Access Compliance Report

Public Rights-of-Way

Intersection ID: 10319	Main Street: BACON_AV	Cross Street: ROZZELLES_FERRY_RD	Location: N
ADA ID: 4064BB77BC5F	Ramp Type: BlendTrans2	Initial Pass/Fail: Fail	Overall Compliance: No
		Severity Score: 10

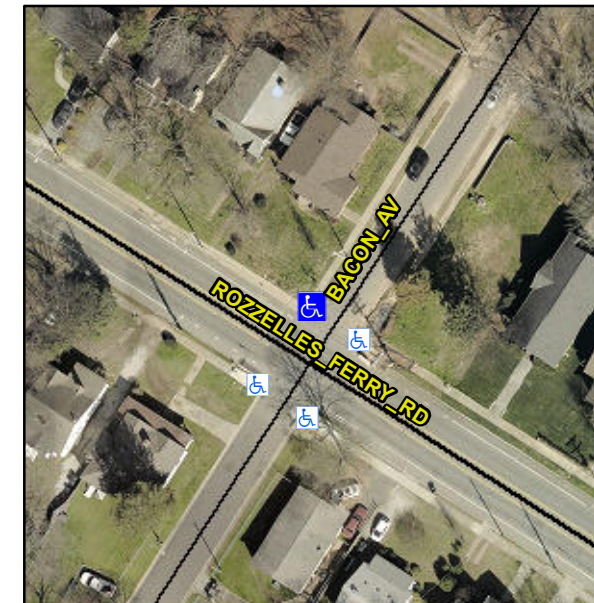
Not Found, R304.5.1, R304.5.3

Compliance	Description	Data	Compliance	Description	Data
N/A	Ramp Length (in)	68.0	Yes	BlendTrans Slope (%)	4.0
No	Ramp Width (in)	46.0	No	BlendTrans XSlope (%)	2.3
N/A	Flare Type LT	N/A	N/A	Flare Type RT	N/A
N/A	Flare Slope LT (%)	N/A	N/A	Flare Slope RT (%)	N/A
N/A	Flare Traversable LT?	N/A	N/A	Flare Traversable RT?	N/A
N/A	Landing Length (in)	N/A	N/A	DWS Provided?	N/A
N/A	Landing Width (in)	N/A	N/A	DWS Contrast?	N/A
N/A	Landing Slope (%)	N/A	N/A	DWS Length (in)	N/A
N/A	Landing X Slope (%)	N/A	N/A	DWS Full Width?	N/A
N/A	Landing Curb? (Y/N)	N/A	N/A	DWS Offset (in)	N/A
N/A	Shared Landing?	N/A			
N/A	Gutter Ponding?	N/A	N/A	Gutter Slope (%)	N/A
N/A	Gutter Lip Ht (in)	N/A	N/A	Gutter X Slope (%)	N/A
N/A	Painted X Walk1?	No	N/A	Painted X Walk2?	No
	X Walk 1 Direction	To SW		X Walk 2 Direction	To SE
	X Walk 1 Width (in)	N/A		X Walk 2 Width (in)	N/A
	X Walk 1 Slope (%)	5.4		X Walk 2 Slope (%)	7.2
	X Walk 1 X Slope (%)	5.5		X Walk 2 X Slope (%)	1.9

N/A	Ramp inside XWalk1?	N/A	N/A	Ramp inside XWalk2?	N/A
	Road Slope (%)	2.6		Clear Space?	N/A
	Road X Slope (%)	9.0	N/A	Clear Space to XWalk (in)	N/A
N/A	Any Obstructions?	N/A	N/A	Storm Grate/Utility Hazard?	N/A
	Obstruction Type			Storm Grate/Utility Type	
		N/A			N/A
			Yes	Surface Condition? (G/P)	Good
			No	Curb Slope (%)	7.4

Remove & Replace Curb Ramp With Two New Directional Ramps or Equivalent.
